No.	1893	PCN Date	September 30, 2011	Effective Date	December 30, 2011
Title	Alternative Format for Trace Codes

Description and Purpose – Affected Products

Current Trace Code

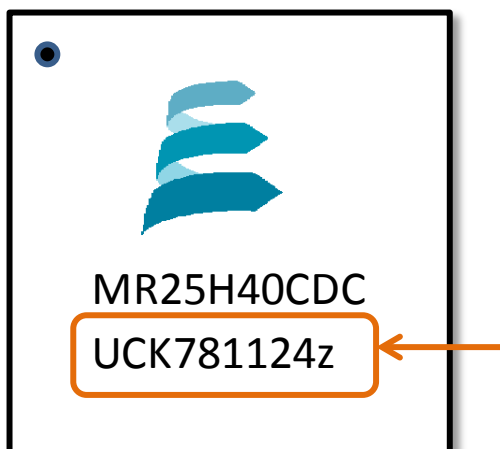
Current trace code format **FATWLYYWWz**

F = Wafer FAB
A = Assembly location
T = Final Test Location
WL = Wafer Lot Number
YY = Year
WW = Work Week
z = Assembly lot split (may not be present)

Alternative Trace Code

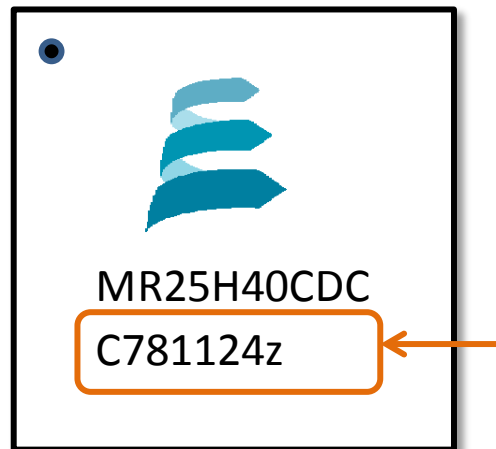
In the alternative format letter codes for wafer fabrication location and final test location will not be included in the trace code. The letter code for assembly location will be retained. *Wafer fabrication and test sites will always be traceable through the date code.*

Alternative trace code format **AWLYYWWz**

A = Assembly location
WL = Wafer Lot Number
YY = Year
WW = Work Week
z = Assembly lot split (may not be present)
